REFERENCE:	Nova Bus Manuals
SECTION:	10 Transmission and control
RS N°:	MQR 7621-315
EFFECTIVE IN PROD.:	L702 (2012MA)

SUBJECT:	Ecolife transmission with oil level sensor - Wiring harness for recording of turbine speed and output speed. ZF BULLETIN No. 12_07.
JUSTIFICATION:	Due to wear at the plug connections of the wiring harnesses, sporadic contact discrepancies and entries in the error memory may occur.

Wiring Harness for Speed Recording of Turbine Speed (N_T) and Output Speed (N_Ab)

Components concerned:**Nova Bus note:**

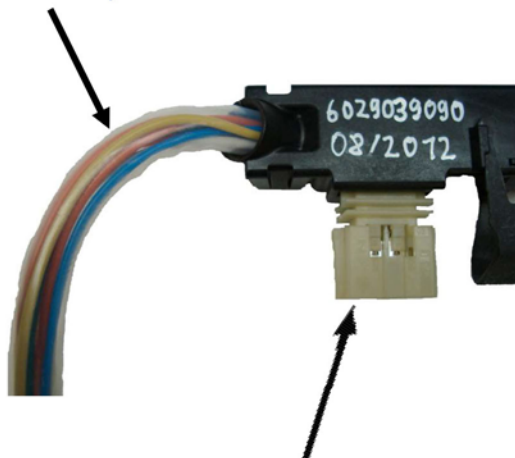
In case of error, the wiring harnesses must be exchanged according to the following table:

Designation	NEW	OLD
	Material number	Material number
Wiring harness internal, turbine speed (N_T)	6029.039.090	6029.039.048
Wiring harness internal, turbine speed (N_T) with oil level sensor	6029.039.106	6029.039.061
Wiring harness, output speed (N_AB)	6029.039.091	6029.039.049

The new wiring harnesses are clearly visible due to different individual lines in terms of color.

Due to improved plug connections, higher forces for plugging the wiring harnesses in are necessary!

The wiring harness of the output speed (N_Ab) can be exchanged with small work efforts. If the oil pan is removed, an "insertion aid" (wire or something similar) is mounted to the wiring harness to be exchanged; with the help of this "insertion aid", the new wiring harness can then be inserted.

The transmission has not to be removed for the exchange of the wiring harness of the output speed (N_Ab).

During the retrofit in the vehicle, the plug connector locking mechanisms can break off, in this case, the wiring harness must be replaced. (do not necessarily exchange!!!!)
